# In the Drawings:

## **REMARKS**

Amendment to the Specification and Replacement of Figure 4B

Figure 4B

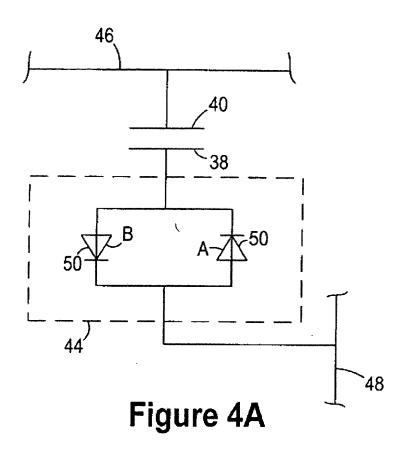
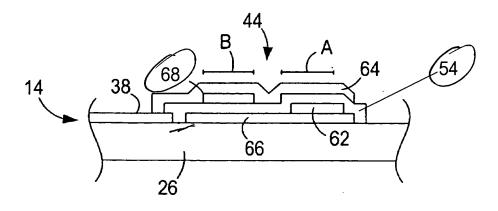
New Figure 4B is attached. Please replace Figure 4B with the new Figure 4B. The following changes were made to Figure 4B to bring Figure 4B in agreement with the specification:

- 1). Label 60 was replaced with label 54.
- 2). Label 64 within the diode B was replaced with label 68.

A red-lined copy of new Figure 4B is provided to illustrate the changes that were made.

Two labels were changed in Figure 4B to bring the new Figure 4B in agreement with the specification. Specifically, label 60 was replaced with label 54, and label 64 in the diode B was replaced with the label 68.
